RE: DEIR Comments

General Electric Company ("GE") is pleased to submit these comments on EPA's February 1997 Data Evaluation and Interpretation Report ("Report") for the Hudson River PCBs Reassessment Remedial Investigation/Feasibility Study.

COMMENTS OF GENERAL ELECTRIC COMPANY ON

PHASE 2 REPORT - REVIEW COPY  
FURTHER SITE CHARACTERIZATION AND ANALYSIS  
VOLUME 2C -  
DATA EVALUATION AND INTERPRETATION REPORT  
HUDSON RIVER PCBs REASSESSMENT RI/FS  
FEBRUARY 1997

Figure E-1. Partition coefficients as a function of river mile calculated from EPA Phase 2 water column monitoring transect studies 2-6.

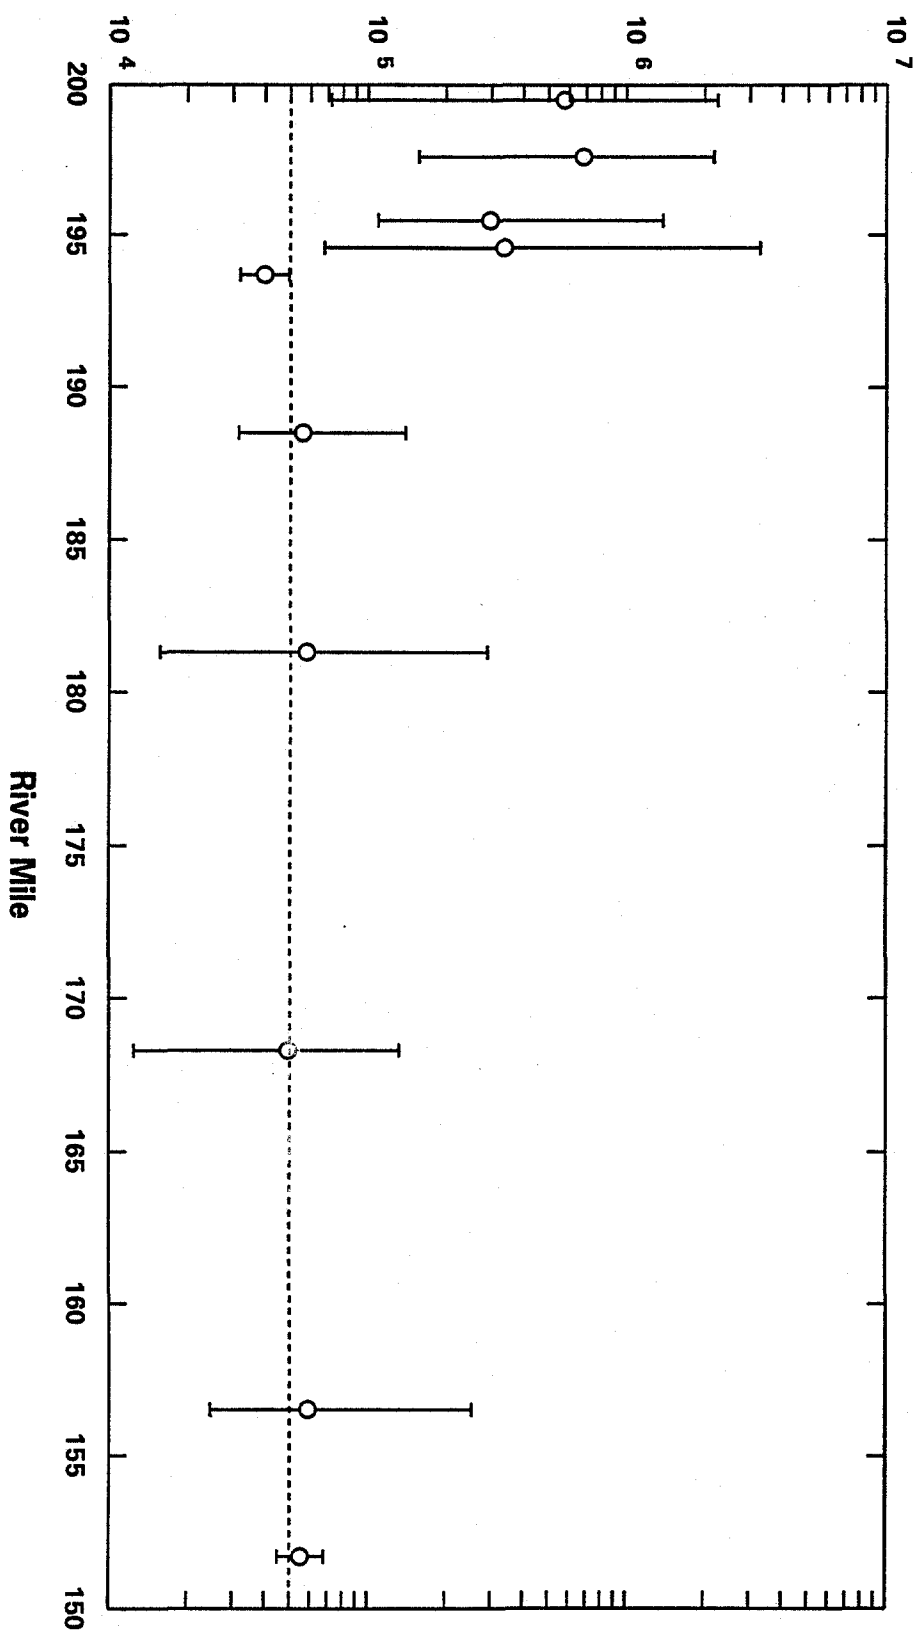
different behavior from those below the dam. Figure E-1 shows the average and range of total PCB partition coefficients for Transects 002-006 vs. river mile. Note the relatively constant values for  $K_p$  beginning at the TI Dam of about 50000 l/kg and the distinctly higher values upriver. This difference cannot be attributed to a change in organic content of the solids. Figure E-2 shows estimated log  $K_{OC}$  values plotted against log  $K_{OW}$  (as reported by Hawker and Connell). For the Thompson Island Dam, Schuylerville, and Waterford stations, the  $K_{OC}$  pattern is relatively uniform throughout all transects, and is reasonably well represented by  $K_{OW}$ . The Fort Edward station estimates show a much different pattern, being generally higher than the other stations and exhibiting a higher degree of variability.

Figure E-3. Log K<sub>oc</sub> of BZ#10 as a function of inverse temperature. Only Transect studies 1-6 from the Thompson Island Dam to Waterford: Left, with temperature correction; Right, without temperature correction.

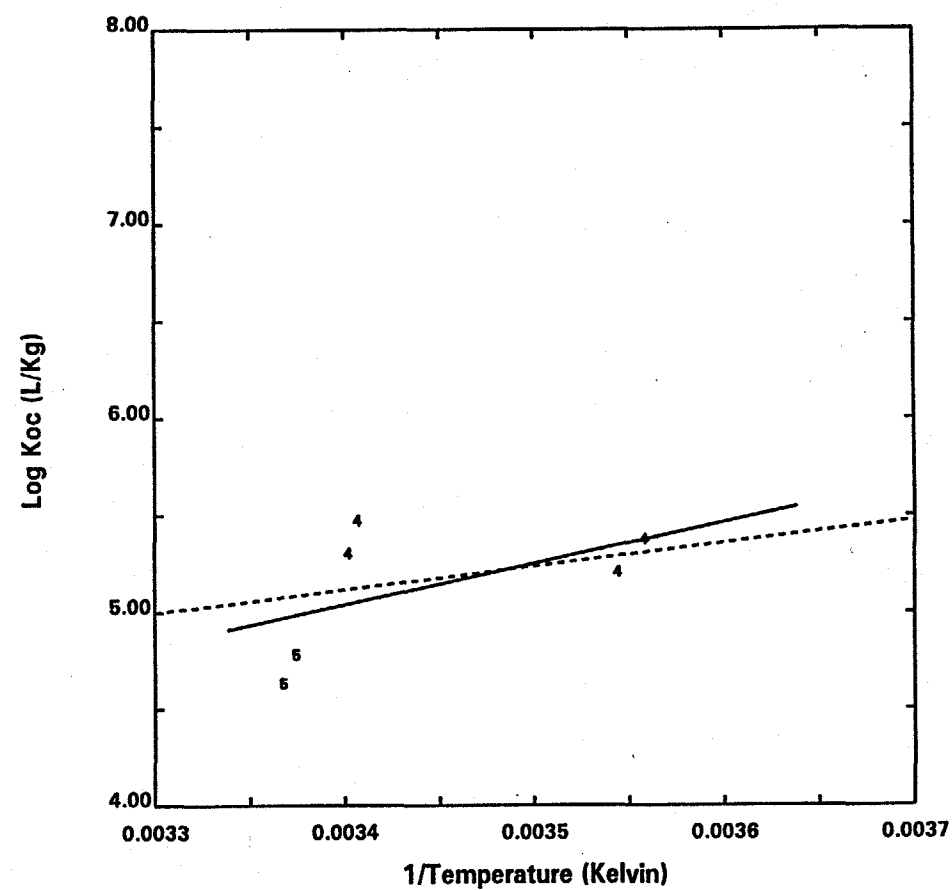
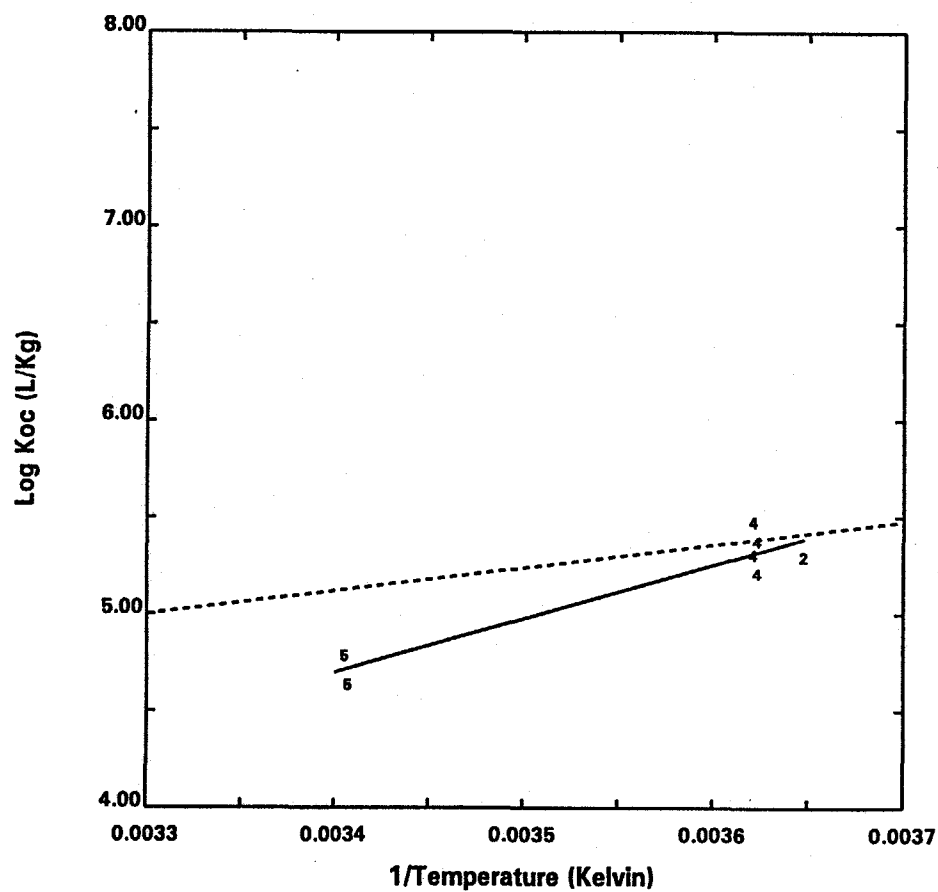
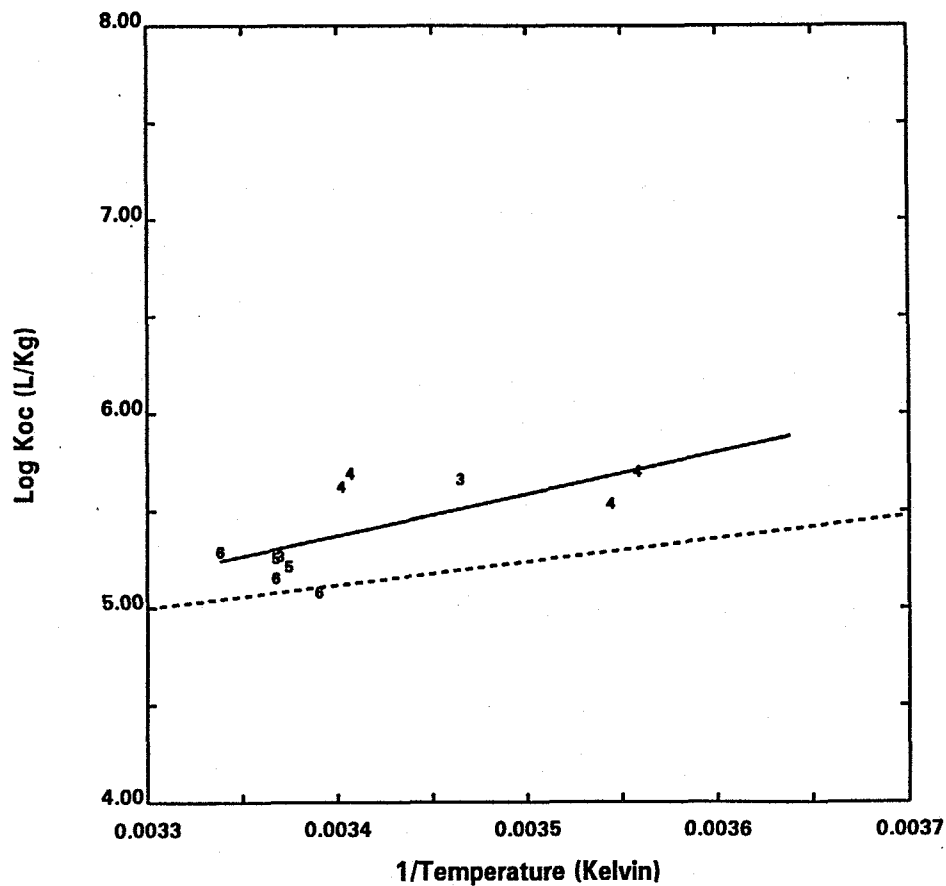
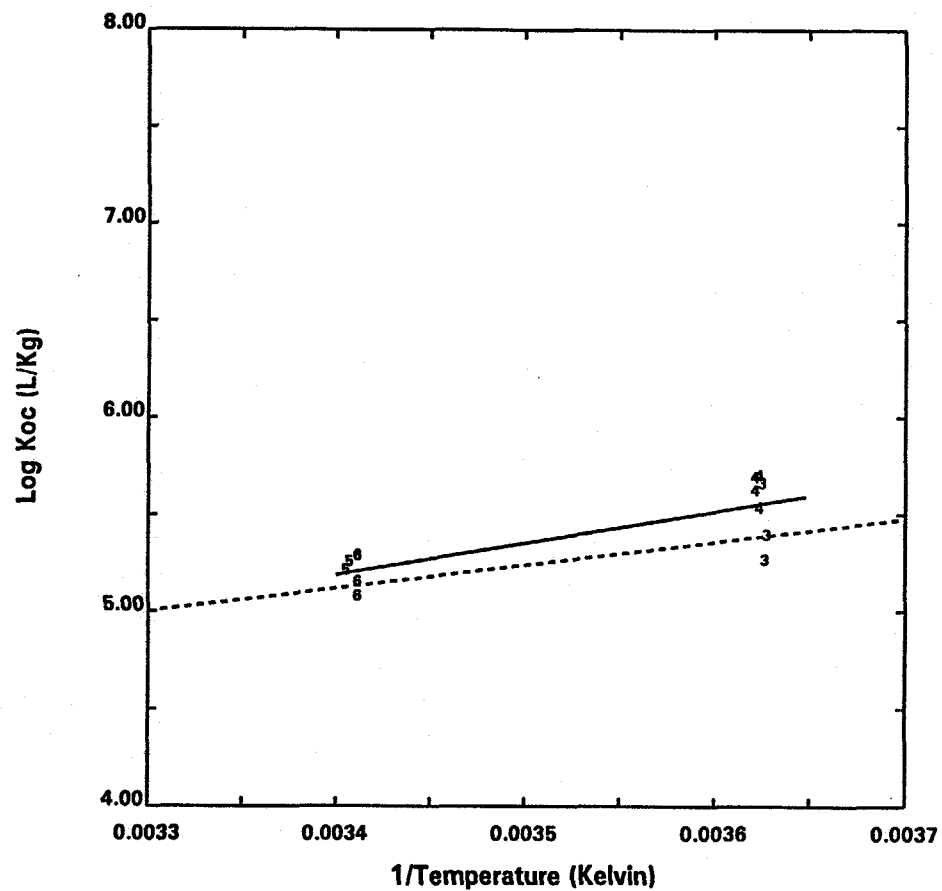
The analysis of the temperature dependence of partition coefficients (p 3-16) is based upon historical data reported in Warren, et al (1987). It is not clear why this data was used to determine the temperature dependence of partition coefficients when the Phase 2 data collected covers a sufficient range in temperature to determine temperature dependence directly. Figures E-3 and E-4 show  $\log K_{oc}$  vs  $1/T$  for congeners 10 and 27.

It should be noted that these values of temperature have been corrected to ambient river temperature. Figures E-3b and E-4b show  $\log K_{oc}$  vs  $1/T$  for congeners 10 and 27 based on the temperature reported in the Phase 2 data. That this temperature is not ambient is evident by the large temperature differences within transects as well as the reporting of high (~20 degC) temperatures in the early Spring surveys. Figure E-5 shows a comparison of ambient TI Dam water temperature data collected by OBG as compared to those reported in the Phase 2 transect data. In all transects the reported Phase 2 temperature is higher than ambient. It is not clear when and where the Phase 2 temperatures were taken, especially in relation to the time of filtration of water samples. If the filtration was performed before samples reached equilibrium at the higher temperatures, values of  $K_{oc}(20)$  will be biased high.

Figure 3. Annual sediment scour depths required to achieve water column concentrations necessary to maintain the TIP load.

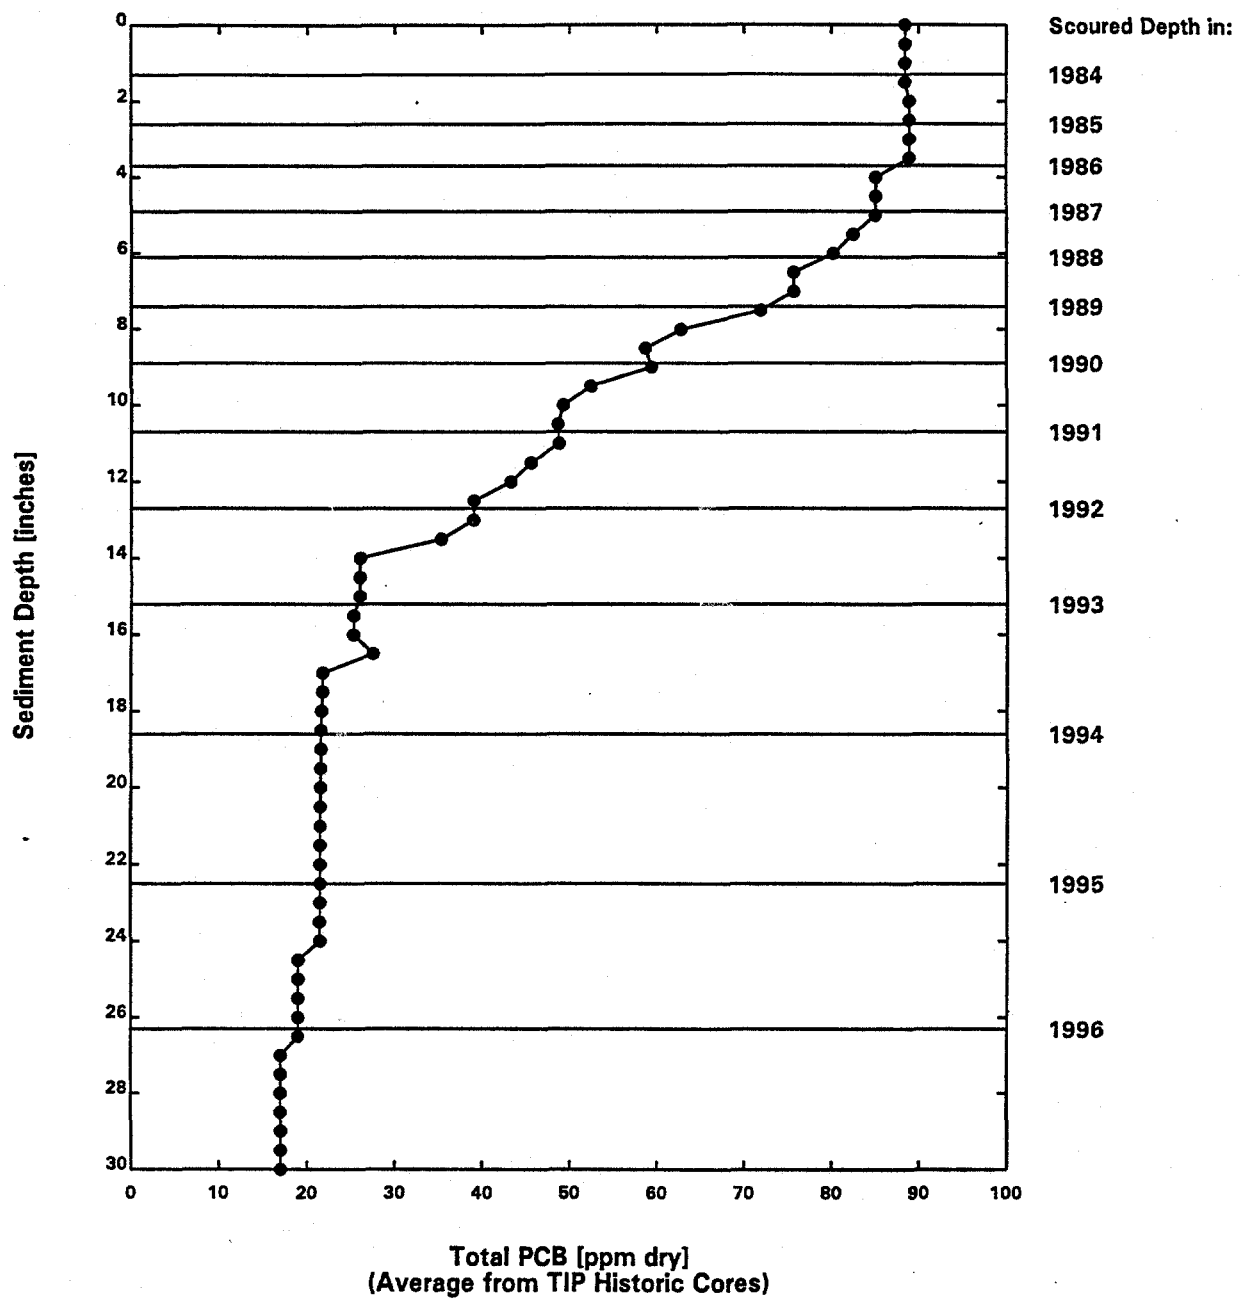
Figure 3 presents the depth of scour required on an annual basis to achieve the concentrations necessary to maintain the TID load. As can be seen, approximately 75 cm of sediments within these areas would have to have been eroded between 1984 and 1993 to provide the increased load across the TIP. EPA's analysis of its geophysical data indicates that such massive scour has not occurred. Indeed, these data indicate that the aged dechlorinated sediments are largely intact (report at 4-91).

Figure 4. Predicted cohesive sediment bed erosion in the TIP under low flow conditions.

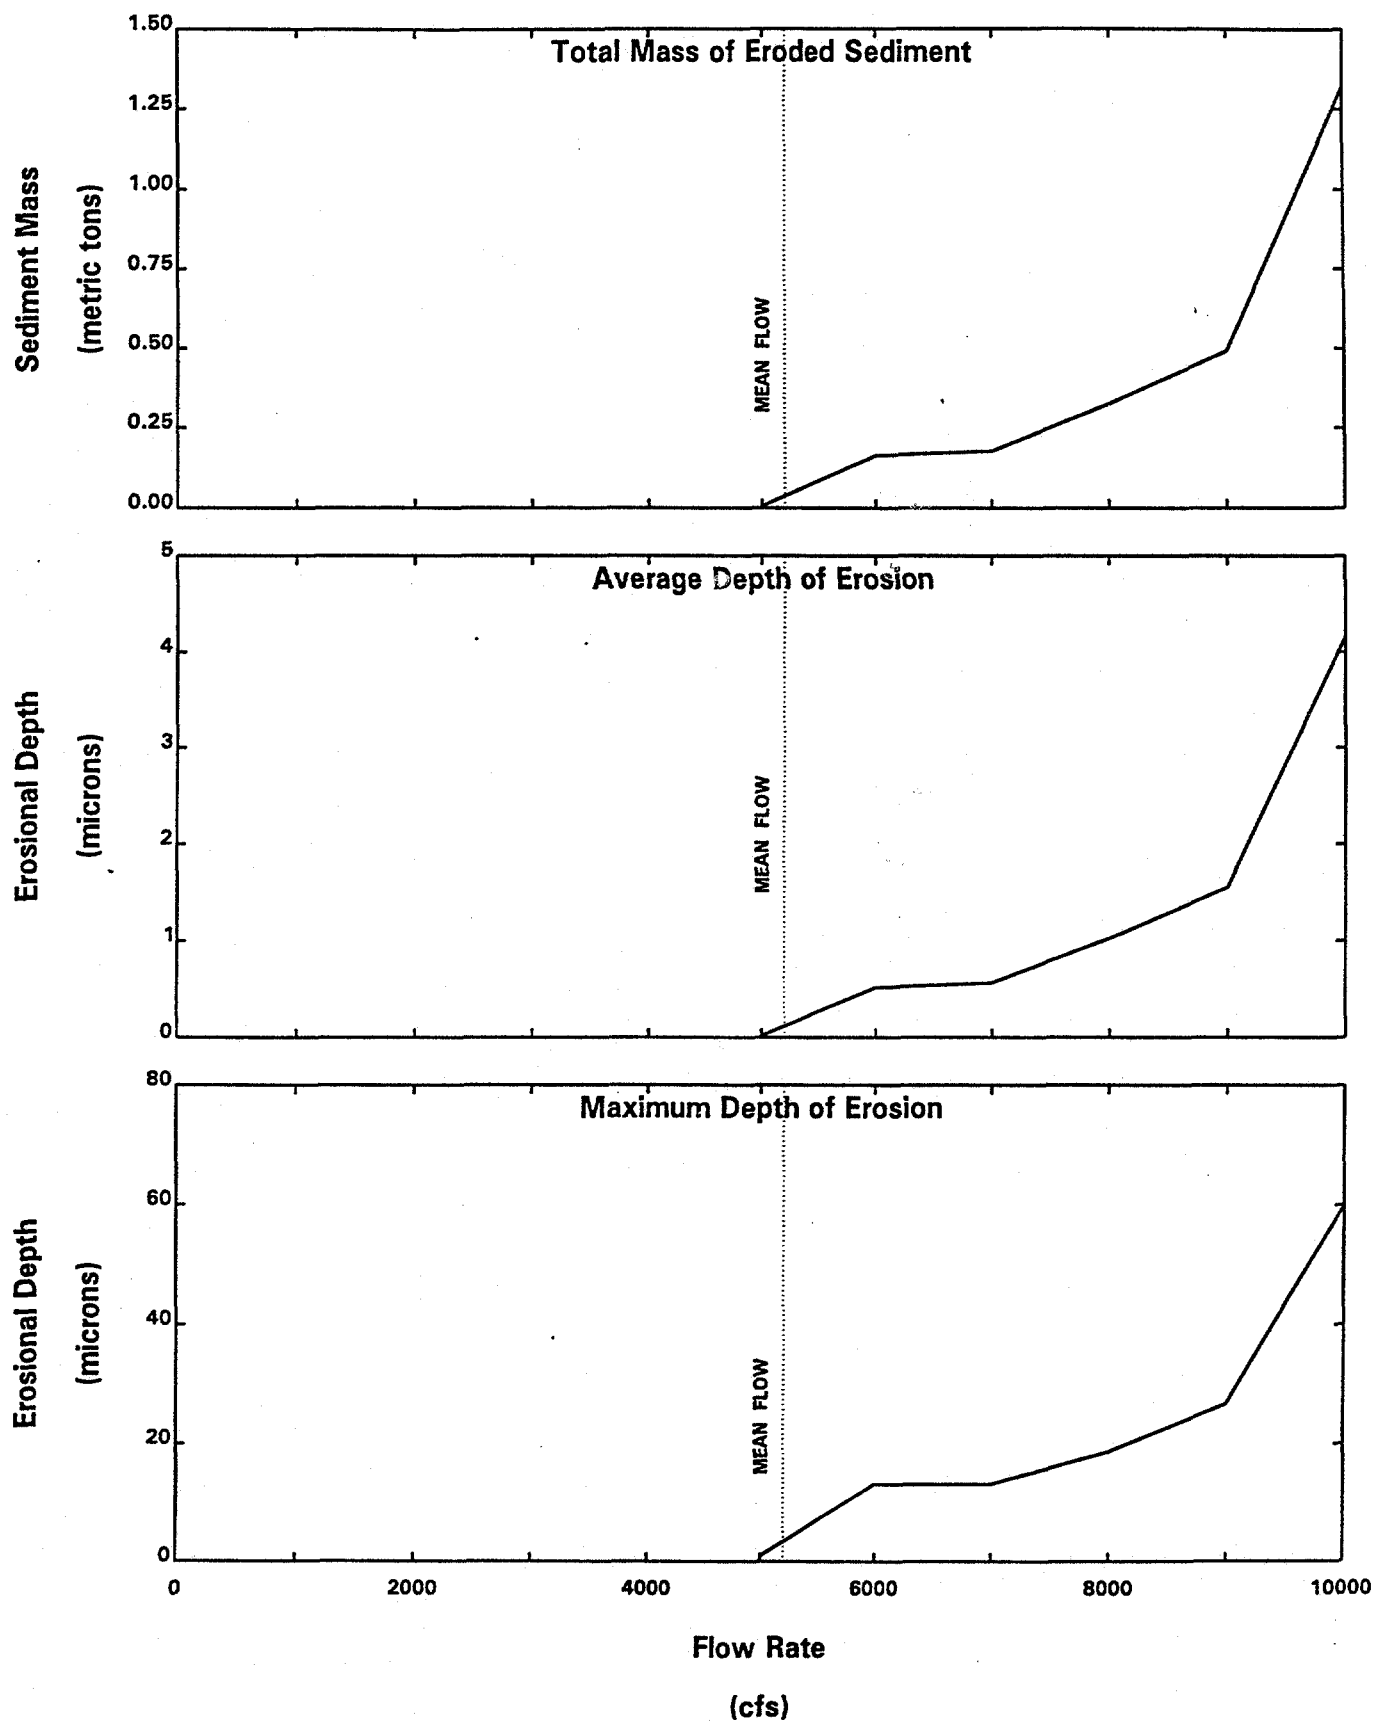
The sediment transport model was thus used to predict resuspension and deposition fluxes in the TIP under low flow conditions. Model simulations show that negligible gross resuspension of the cohesive sediment bed occurs for flow rates less than 5,000 cfs (Figure 4). To further investigate resuspension and deposition dynamics during low flow conditions, a simulation was performed for a constant flow rate of 3,200 cfs at Rogers Island. This flow rate corresponds to the mean value at Fort Edward during the EPA sampling periods in May and June of 1993. The data from this period were the primary basis for the low-flow resuspension hypothesis proposed in the Report. Model results show that net deposition, with only a minimal amount of resuspension, occurs in the TIP at this flow rate. The gross resuspension flux in the TIP is about 1,000 times smaller than the gross deposition flux, and the sediment that is eroded comes from a thin, surficial layer (approximately 10  $\mu\text{m}$  thick) that is composed of loosely-consolidated, recently-deposited sediment (Figure 4). These results, combined with the observed resuspension properties of sediments, demonstrates the implausibility of the Report's hypothesis that relatively high gross deposition and resuspension rates, producing a small net change in water column solids load, caused the observed changes in PCB loading through the TIP during the 1993 low-flow periods.
